## **DESIGN REVIEW BOARD – SPECIAL HEARING**

**Design Review Board Case # 2021-0001**

**Block 23 – 2121 and 2111 Eisenhower Avenue**

## I. Block 23 – DRB Concept Review

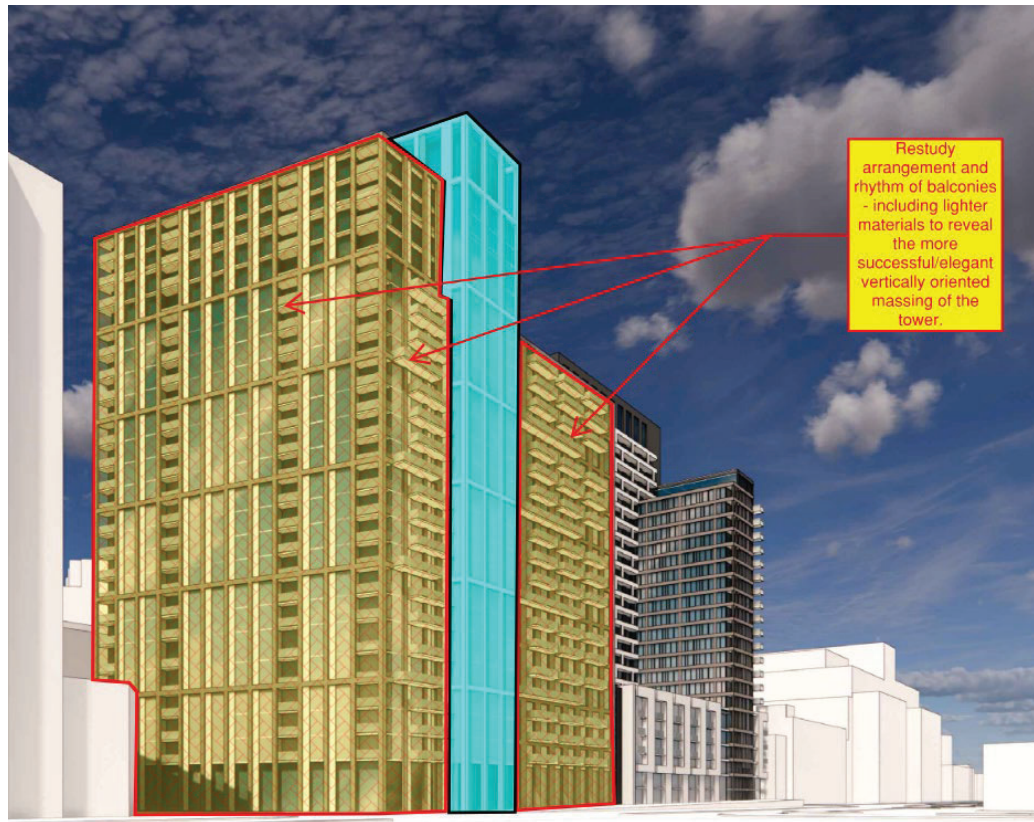
As a general design goal when dealing with multiple towers on a single parcel, Staff has also been working with the applicant to explore strategies to create an actual or perceived difference in height between the two towers – of course, an actual height differential of at least two floors would be preferable. This is also supported by the updated EESAP goal of achieving a “*varied skyline*.” While the affordable housing height/density bonus option did not appear to work for this situation, an option spelled out in the updated EESAP appears to offer a possible strategy. As stated in the plan: “*In support of a varied skyline, the Plan supports flexibility for increasing the maximum height limit for blocks that propose taller buildings and a smaller building footprint, as long as they are consistent*

It should be noted that Staff received an updated analysis of this design option from Applicant following the formal DRB submission and have included them as an addendum to this report. If deemed appropriate, Staff hope to include this in their discussion with the DRB.

**FIG 3: Inclined PV integrated glazed façade of Vocational College in Tirol, Austria**

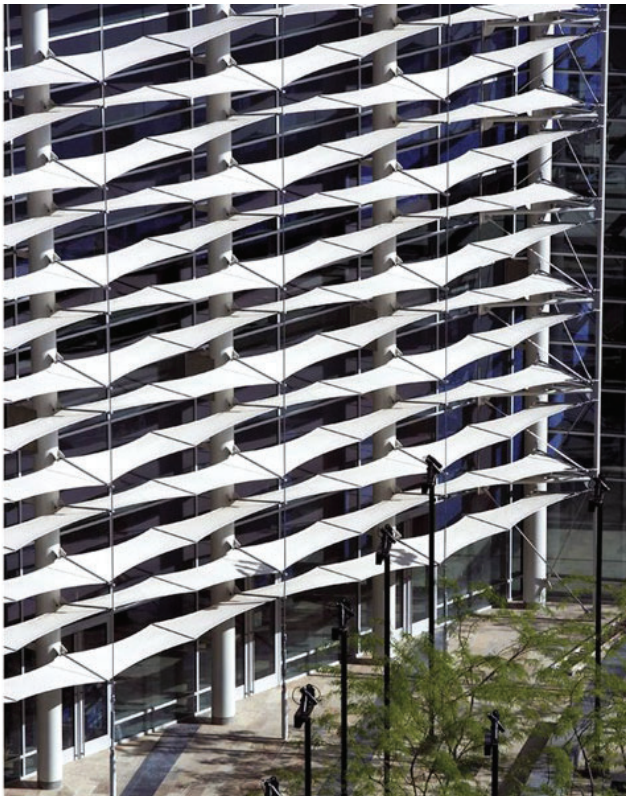
To clarify Staff's language regarding integral solar response and design approaches in which façade components are created that can be interchanged to create a variety of effects, the following examples may prove helpful in the Board's discussion or applicant's further exploration. These employ precast concrete, which could be an effective cladding system for buildings on this scale as well.
